Central Planning Authority

Agenda for a meeting of the Central Planning Authority to be held on **25 September 2024 at 10:00am** in Conference Room 1038, 1st Floor, Government Administration Building, 133 Elgin Avenue

CPA/24/24

Figure 1. The current application site highlighted in red with the approved subdivision to be connected highlighted in blue (Aerial Imagery Source: UKHO, 2021).

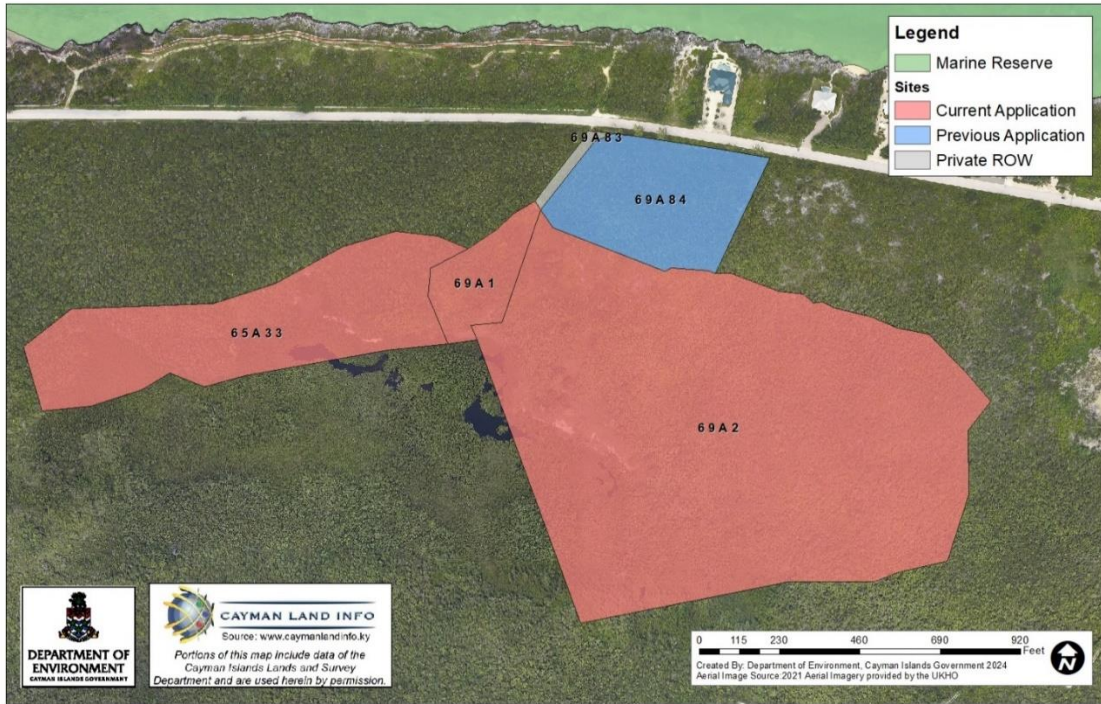
As seen in Figures 1 and 2, the application site contains primary dry forest and shrubland, seasonally flooded mangrove forests and shrubland, and freshwater ponds. There are some man-modified areas within the parcel as well but they contain old regrowth which still provides valuable ecosystem services. The site is also located in proximity to the Salina Reserve, a large area of undisturbed habitat owned by the National Trust and home to nearly every type of living organism in the Cayman Islands, including the endemic Blue Iguana.

Figure 3. The application site with the proposed subdivision site highlighted in proximity to the Salina Reserve (UKHO, 2021).

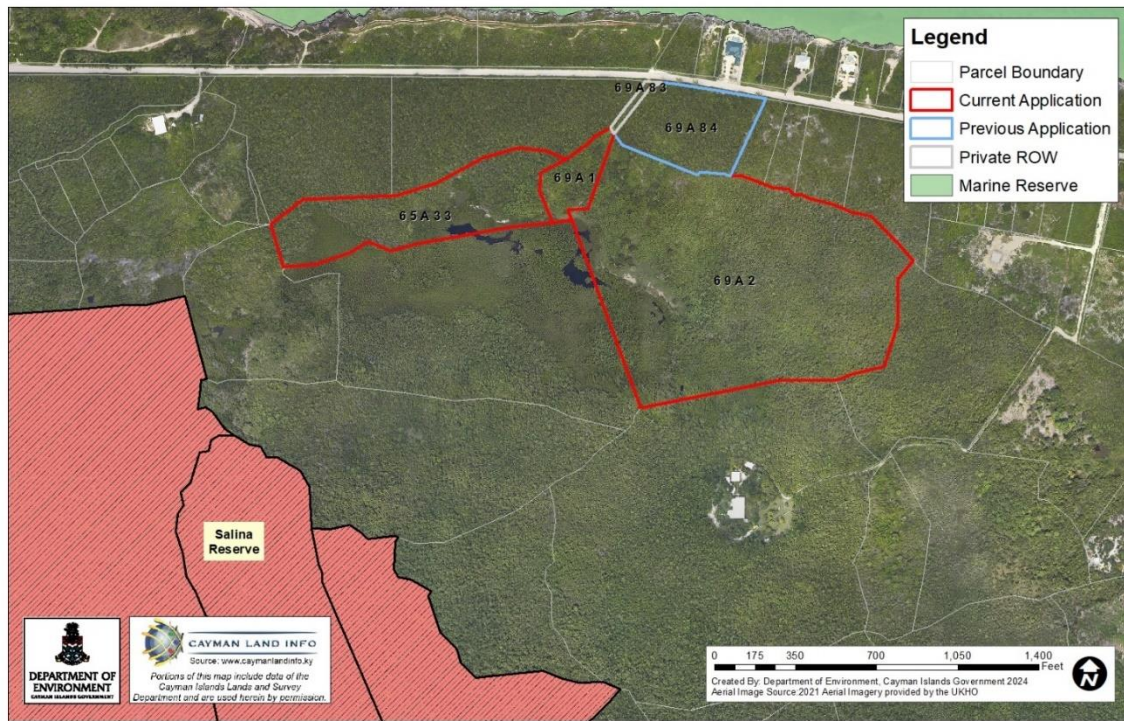
The Grand Cayman Blue Iguana (*Cyclura lewisi*) is a large herbivorous reptile unique to the Cayman Islands, found only on Grand Cayman, and listed as a Part 1 of Schedule 1 Protected Species in the National Conservation Act which are protected at all times. As seen in Figure 3 below, the application site is in proximity to the Salina Reserve where the endemic Blue Iguana typically resides. However, the Blue Iguana has an extensive dispersal range and have been recorded nesting and breeding in primary habitat outside of the Salina and Colliers Reserves. It should be noted that there has been recorded Blue Iguanas in the parcels directly south of the proposed subdivision site therefore, it is highly likely that there are Blue Iguanas present in the subdivision site as well.

Figure 1: 2021 aerial imagery showing the break in the reef where the outflow exits creating strong currents in front of the application site outlined in light blue. (Imagery Source: UKHO, 2021)

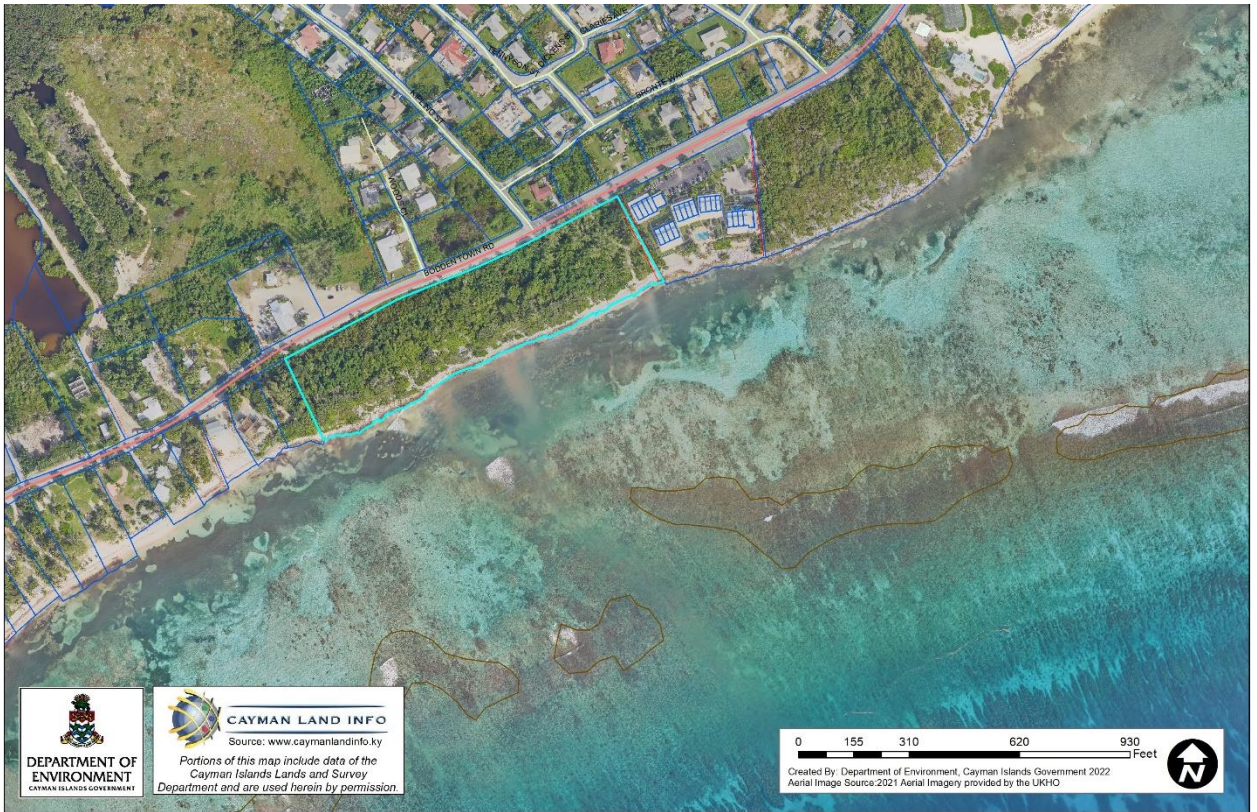
The Department wishes to highlight that there are strong currents in this area. The water that comes over the reef exits through the break in the reef at this location as shown in Figure 1 below. These currents may make it unsafe for some in-water activities such as offshore swimming and snorkeling.

Image 1: Extract of proposed site plan

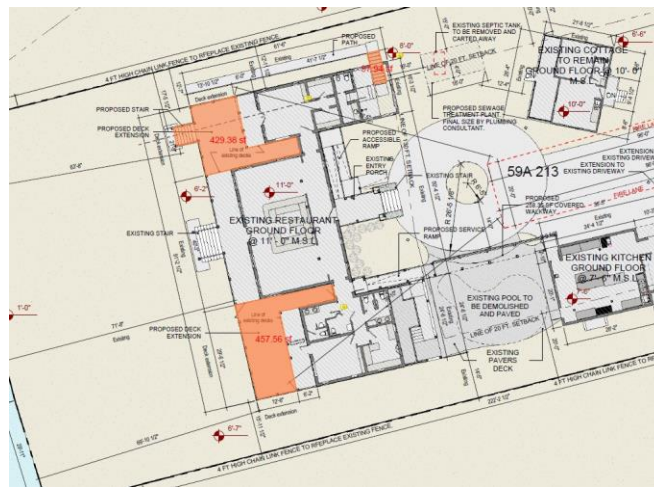
- (i) *Side setback for restroom steps along the northern boundary: Requesting 11' 3" vs 20'*
- (ii) *Side setback for rear deck extension along northern boundary: Requesting 17' 6" vs 20'*
- (iii) *High watermark setback for steps leading onto new rear deck extension: Requesting 63' 8" v 130'*
- (iv) *High watermark setback for new rear deck extension sited along southern boundary: Requesting 71' 8" v 130'*
- (v) *Side setback for new rear deck extension sited along southern boundary: Requesting of 16' v 130'.*

The following image identifies the extent of deck extensions, highlighted orange, which encroach into the setbacks:

Figure 1. The application site with the parcel boundary highlighted in blue (Aerial Imagery Source: UKHO, 2021).

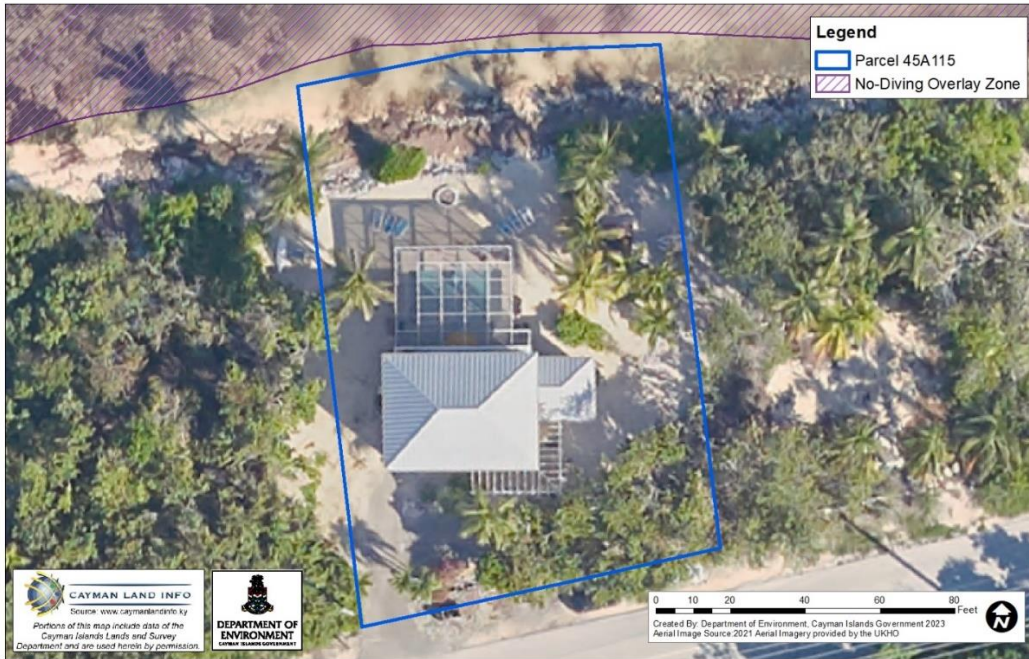
As seen in Figure 1 below, the application site is adjacent to a No-Diving Overlay Zone (a Protected Area under the National Conservation Act) and is predominantly man-modified with an existing house on-site.

Figure 2. The application site with the parcel boundary highlighted in blue and an overlay of the submitted architectural plans (Aerial Imagery Source: UKHO, 2021 & Architectural Plans Source: M. Gonsalves, 2024).

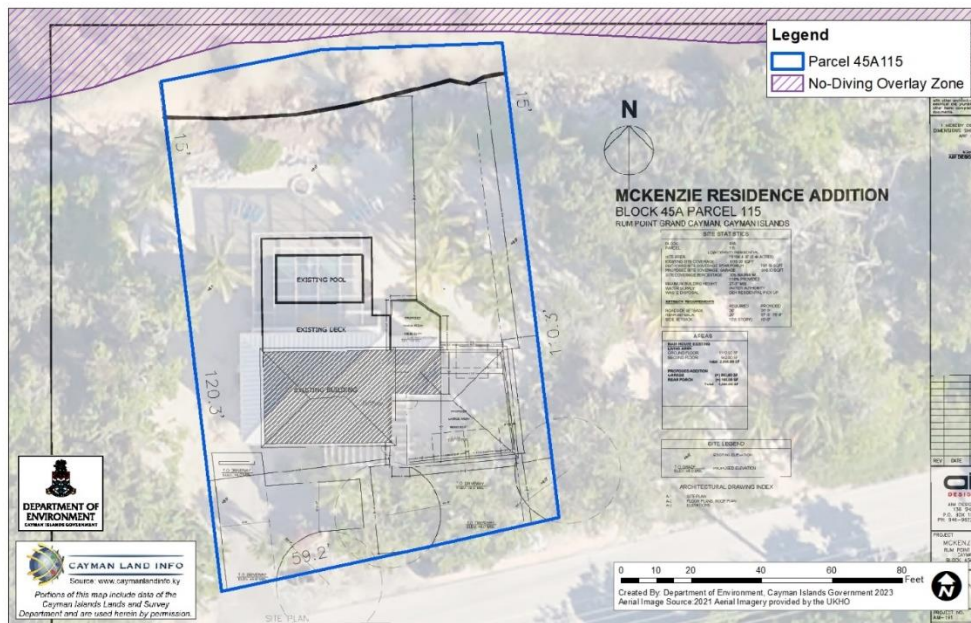
As seen in Figure 2, we note that the setback of the proposed porch falls short of the minimum required setbacks from the registered Mean High Water Mark (MHWM). We note that the proposed porch is as close as approximately 57 feet 5 ½ inch from the MHWM which does not meet the minimum 75-foot coastal setback for beaches. The Department strongly maintains its stance that coastal setbacks should not be reduced but instead should be treated as a minimum. Setbacks seek to reduce the impacts of storm-related damage upon coastal infrastructure and ensure that development does not encroach onto the “active” part of a beach, as the back beach holds reserves of sand that are critical for sediment supply during periods of storm activity and erosion.

The importance of setbacks is amplified when considered within the context of climate change predictions for the region, which include sea-level rise and increased intensity of storm events (including storm surge). Inappropriately sited development (either on the active beach or too close to the MHW) reduces a beach's potential to recover after major events. While we note that the existing pool is also within the coastal setback, we recommend that the applicant revise the submitted plans so that the proposed porch adhere to the minimum 75-foot coastal setback.

Figure 1. The application site with the parcel boundary highlighted in purple (Aerial Imagery Source: UKHO, 2021).

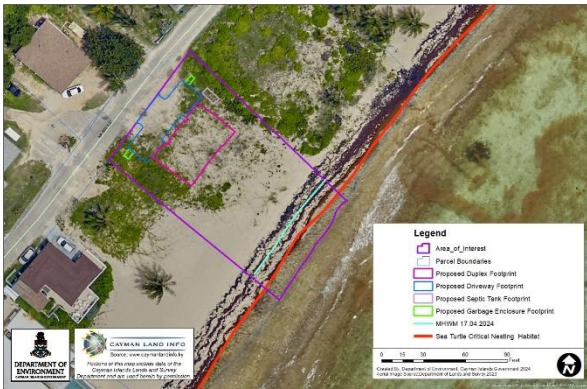
As seen in Figure 1, the application site is man-modified. The beach is designated Critical Habitat for sea turtles as defined in the National Conservation Council's Interim Directive for the designation of Critical Habitat of Green turtles (*Chelonia mydas*), Loggerhead turtles (*Caretta caretta*), Hawksbill turtles (*Eretmochelys imbricata*), Leatherback turtles (*Dermochelys coriacea*) and all other species that may occur in Cayman waters including Kemp's Ridley turtles (*Lepidochelys kempii*) (issued under Section 17 (7) of the National Conservation Act (2013)).
